Studebaker

Service Letter

SUBJECT RELOCATION OF ELECTRICAL CONTROL UNITS
1963 WAGONAIRE W/ELECTRIC TAIL GATE WINDOW

NUMBER J-1963-12

Fig. 1

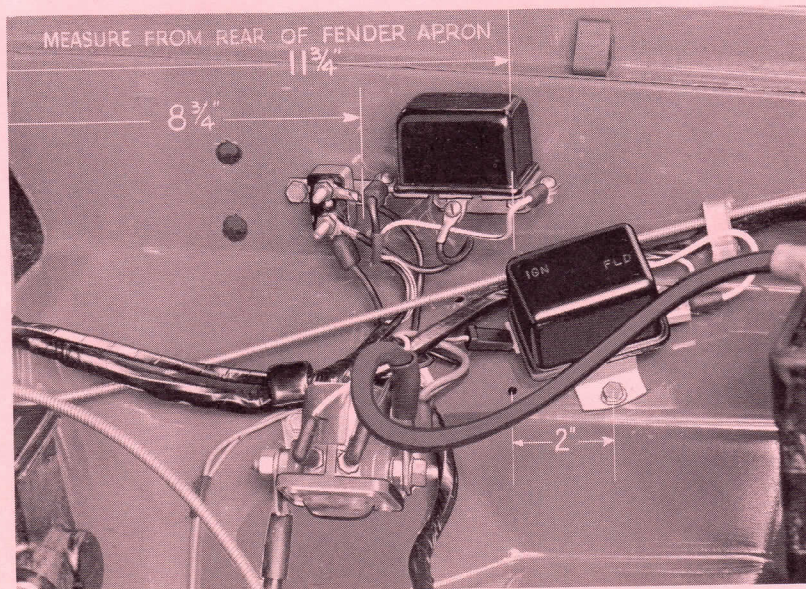
Effective with serial numbers 63S-26025 and 63V-24019 the voltage regulator, tail gate window lift relay and circuit breaker on 1963 Wagonaire models equipped with an electrically operated tail gate window have been relocated further forward on the left front fender apron to eliminate possible interference between the wiring and the hood torsion bar linkage.

You should inspect all 1963 Wagonaire models with electrically operated tail gate windows for interference at this point when the vehicle is in your service department. If interference exists, the voltage regulator, lift relay and circuit breaker should be repositioned as indicated in Figure 1. After relocation of these units, the unused holes in the fender apron should be plugged.
